# Addendum No. Two

RFP No: FY24-805-45 A

Airport Terminal Building Improvements AWIP : BHS-TC2/TC4 : A-Wing Offices

This Addendum # 2 to Request for Bids for Airport Terminal Building Improvements AWIP : BHS-TC2/TC4 : A-Wing Offices contains the following responses to bidder inquiries and clarifications or changes to the Bid Documents:

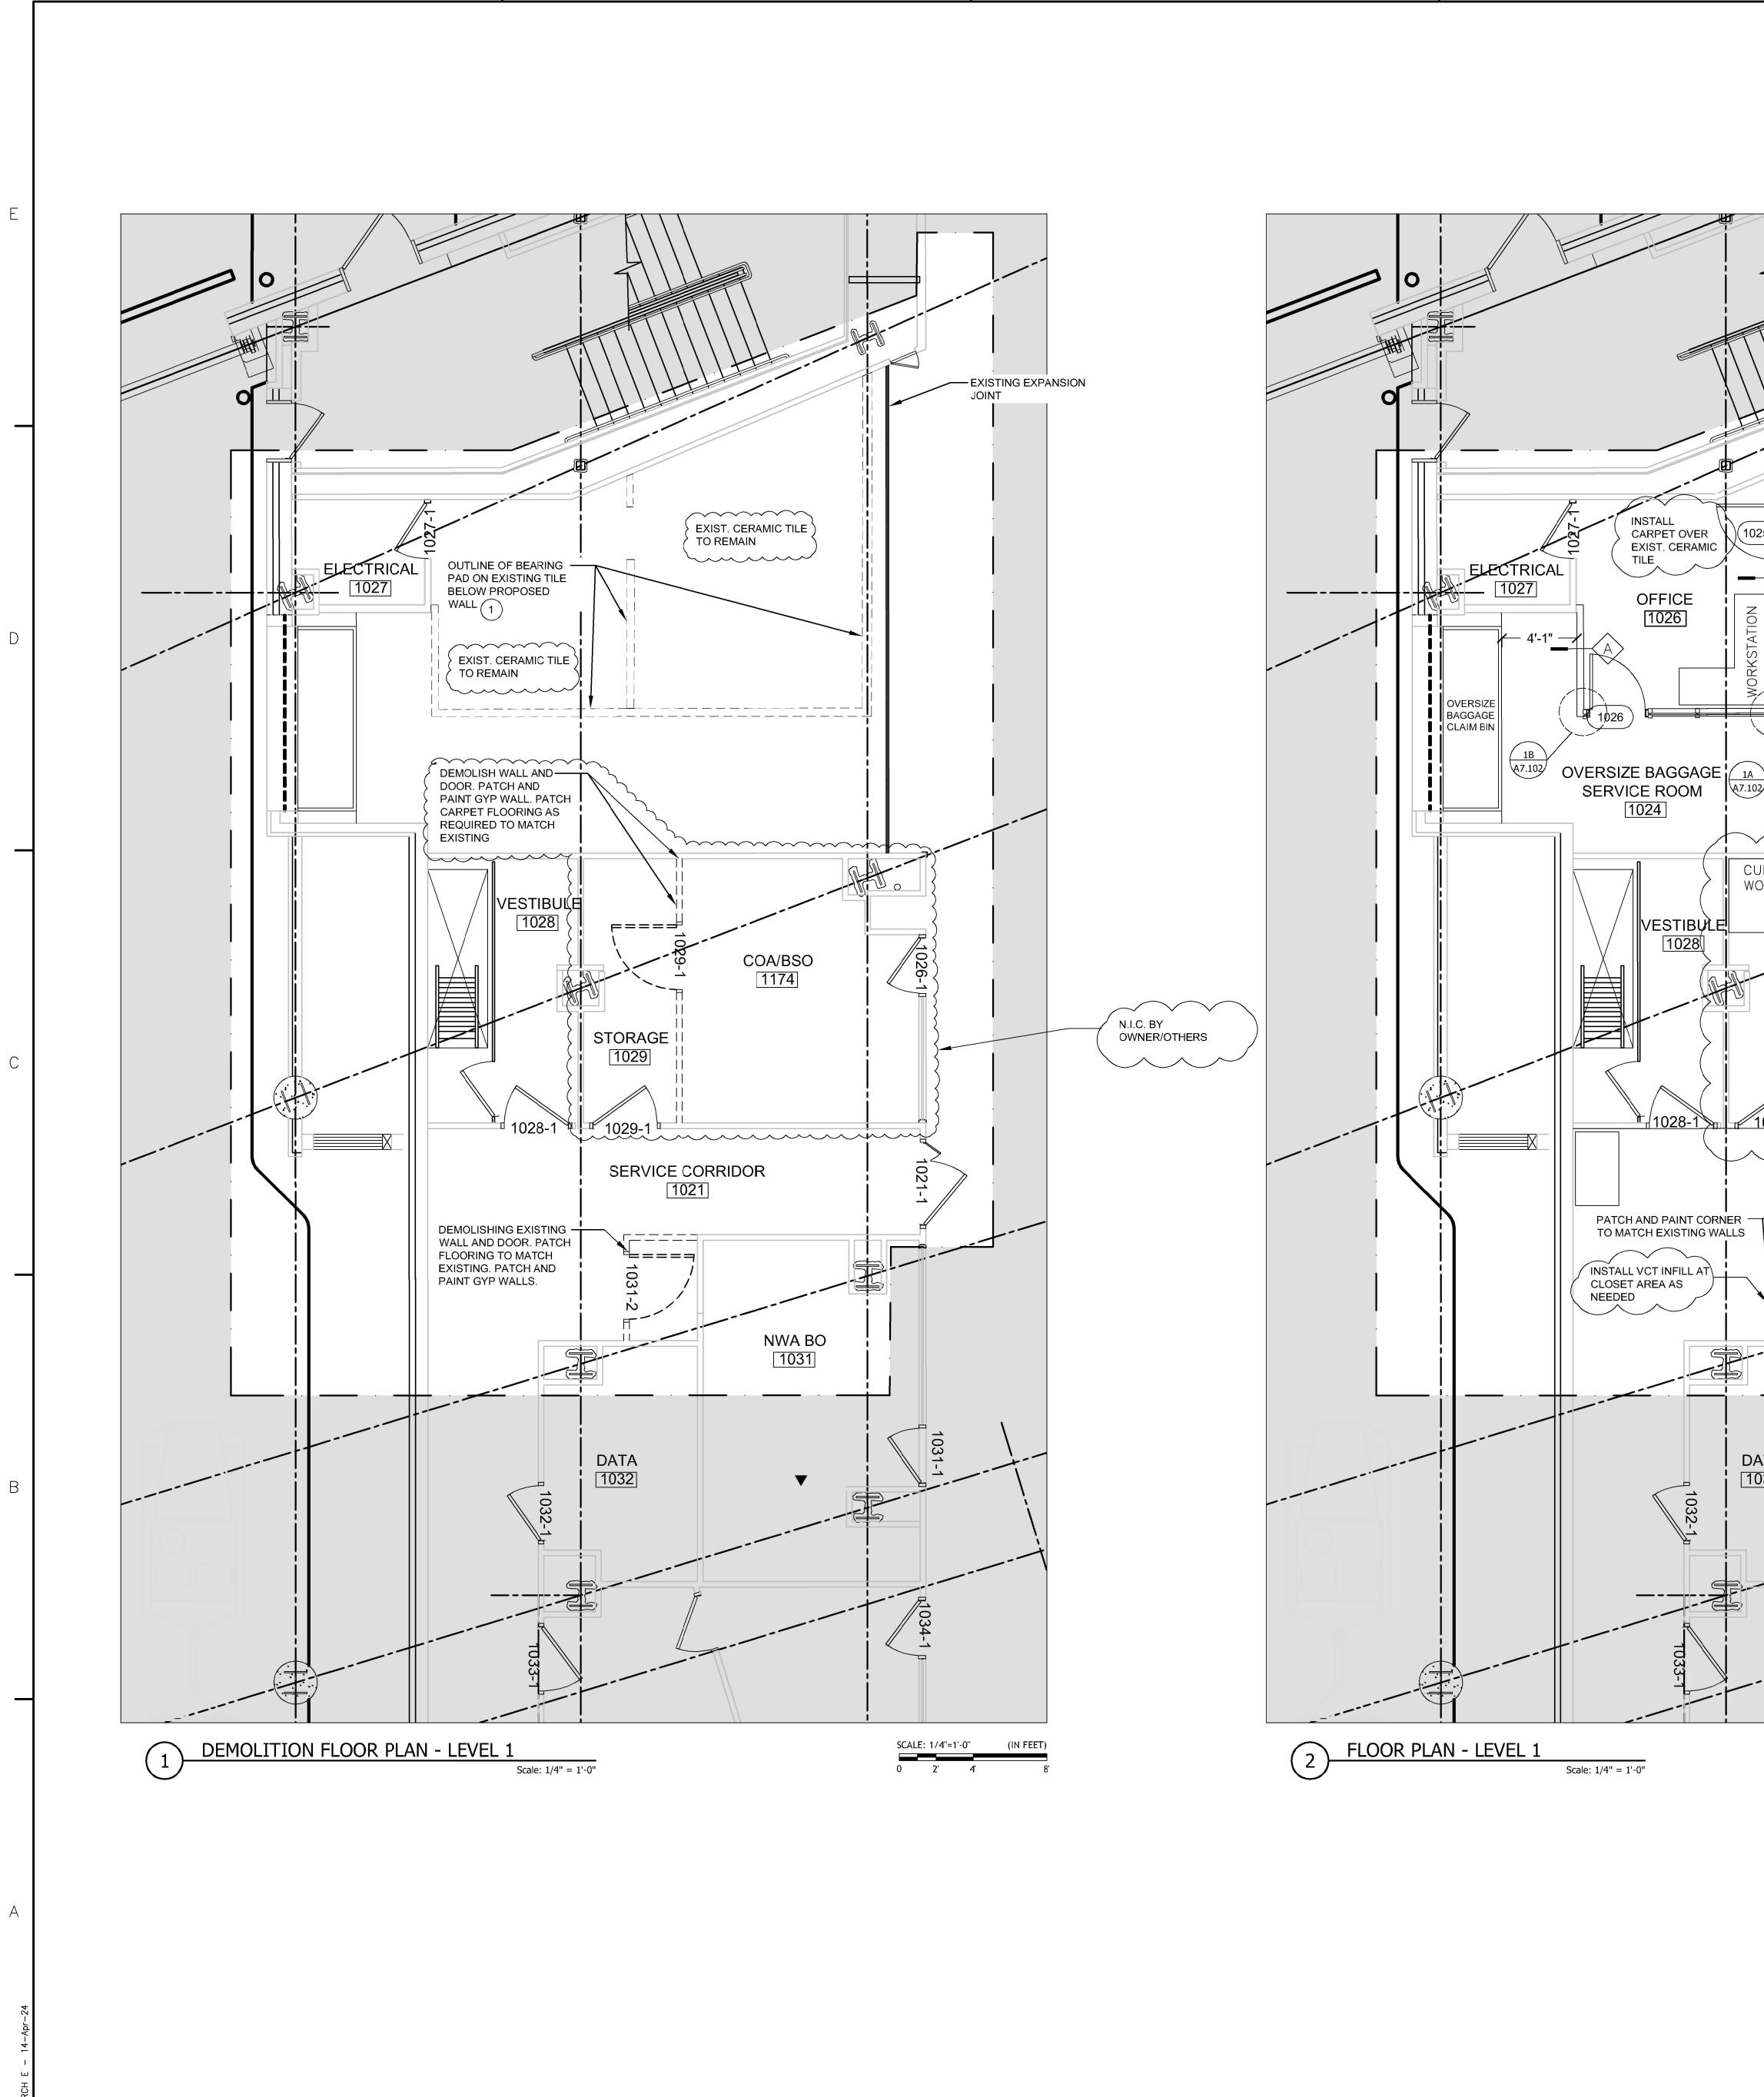
1	BAGGAGE CONVEYOR AND BAGGAGE SCREENING INSPECTION UNIT TO BE REMOVED BY OTHERS
2	TICKET HALL WALL CONVEYOR PENETRATION CLOSURE BY OTHERS. CUT NEW OPENING AND RE-FRAME AS REQUIRED FOR NEW DOOR OPENING
